TECHNICAL QUESTIONS

DOT-ITB-20-7016-LV

DISTRICT SEVEN INTELLIGENT TRANSPORTATION SYSTEM (ITS) ELECTRONIC LOCKS

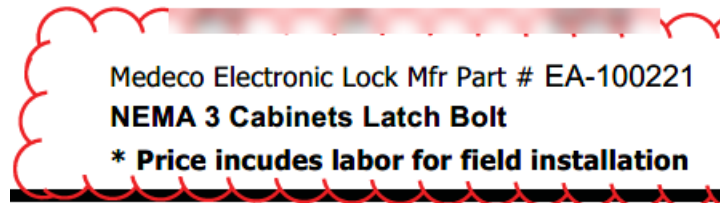
Question 5: The part numbers you sent me only come as the bolt format, but below it's the safe lock that comes in deadbolt and latch. Are you guys looking for the one in the bolt format?

Answer: We want the XT Traffic Cabinet Lock (the fully rectangular plunger is what makes it a "deadbolt" style. We also want the XT traffic Cabinet lock that has the slanted plunger (it's the same part number but with a different description).
